SERVICE BULLETIN

INSPECTION OF EXHAUST MUFFLER PART NO. 979402 / 979404 FOR ROTAX® ENGINE TYPE 914 (SERIES) SB-914-028 R1

MANDATORY

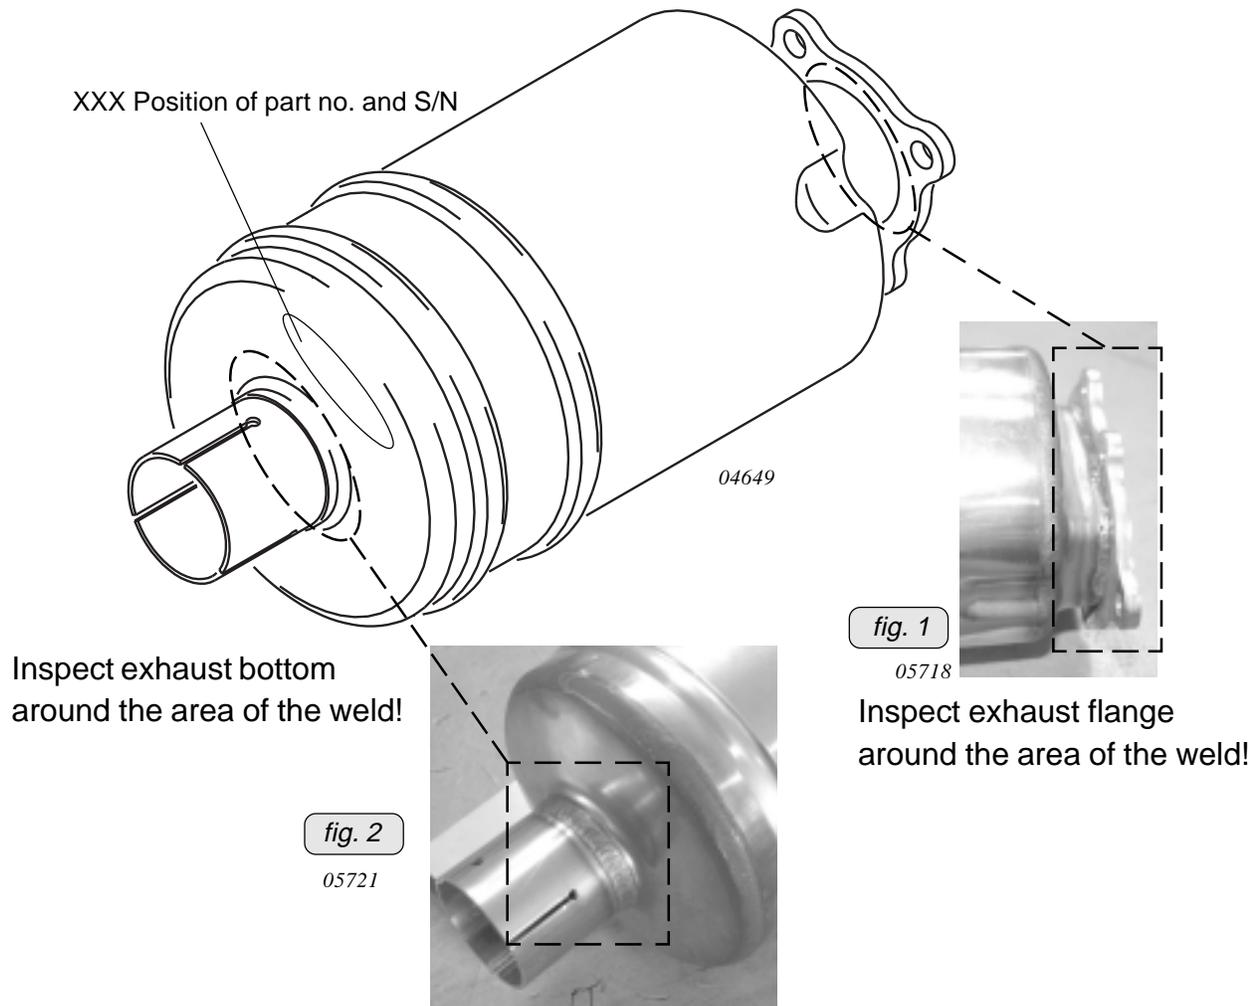
- CAUTION: Inspection in the area (exhaust flange) in the fillet and exhaust bottom visual for exterior traces of smoke or existing cracks as shown in fig. 1 and fig. 2.

- CAUTION: Inspection in the area (exhaust bottom) visual for exterior traces of smoke or existing cracks as shown in fig. 2.
- If exterior traces of smoke or cracks are detected, then you need to replace the exhaust muffler in accordance with the current issue MM 914F.
- Restore aircraft to original operating configuration.
